SUNDRY NOTICE

1. OGCC Operator Number: <u>96850</u>	API Number: _____
2. Name of Operator: <u>WPX Energy Rocky Mountain LLC</u>	OGCC Facility ID # <u>414554</u>
3. Well/Facility Name: _____	Well/Facility Number: <u>14-28-696</u>
4. Location (QtrQtr, Sec, Twp, Rng, Meridian): <u>SW 1/4 SW 1/4, S 28, T6S, R96W, 6TH P.M.</u>

The purpose of this Form 4 is to report modifications of liner specifications at the 14-28-696 production pit. The liner system has been upgraded from the Form 15 permitted 40 mil polyethylene liner to the following specifications:

Starkey Gulch 14-28-696 Production Pit Liner & Leak Detection System Details

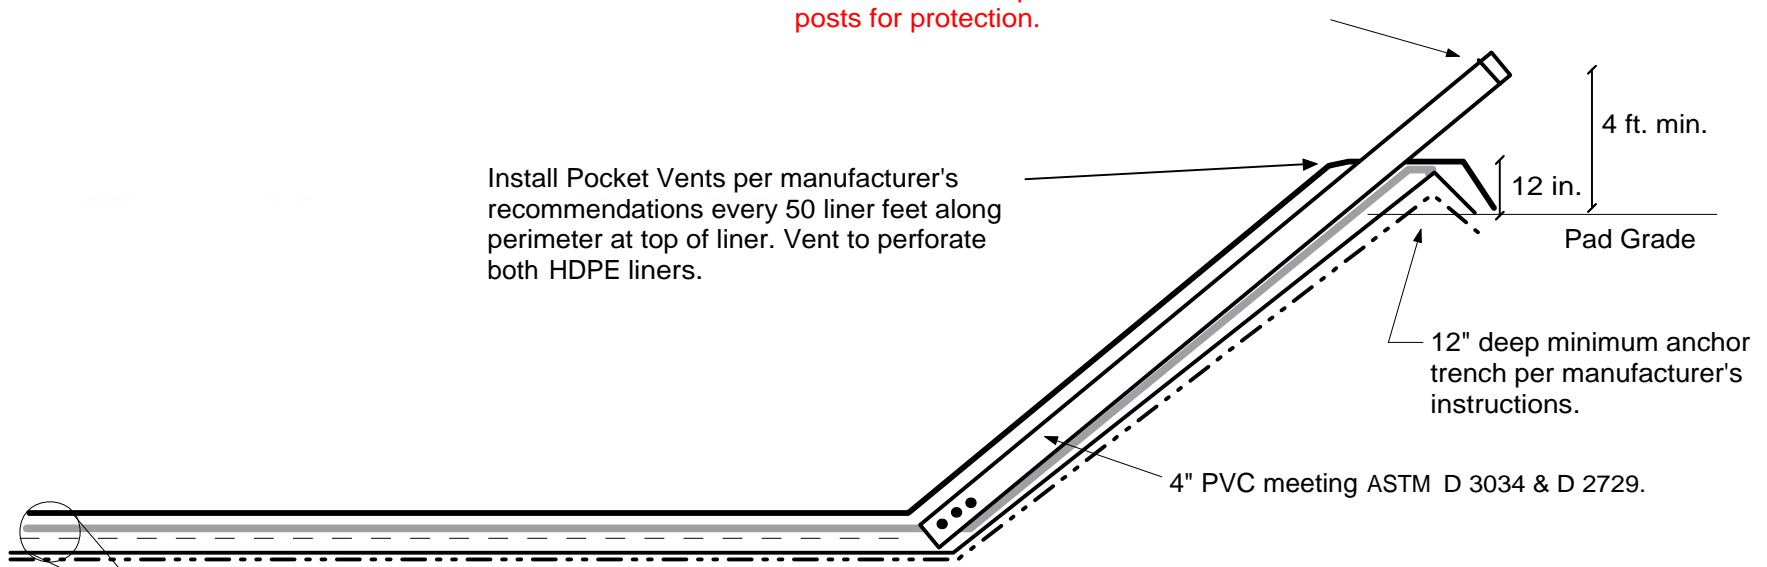
- 60 mil HDPE liner
- 200 mil Hypernet Geonet Drain Mat
- 40 mil HDPE liner (existing)
- two leak detection monitoring stand pipes

Attached is the Liner and Leak Detection System cross-section and Lange Containment Systems Installation Report for the additional 60 mil HDPE liner.

Upgraded Pit Liner System:

- * 60 milHDPE Liner
- * 200 milHypernetGeonetDrain M
- * Woven Geotextile Felt
- * Existing 40 milHDPE Liner
- * Existing Woven Geotextile Felt

Two Leak Detection Monitoring Stand Pipes with 4" PVC Removeable Cap to be located at ends of pit. Place steel fence posts for protection.

Install Pocket Vents per manufacturer's recommendations every 50 liner feet along perimeter at top of liner. Vent to perforate both HDPE liners.

12" deep minimum anchor trench per manufacturer's instructions.

4" PVC meeting ASTM D 3034 & D 2729.

* Install HPDE Liners; Geonet and Vent Pockets per manufacturer's instructions.
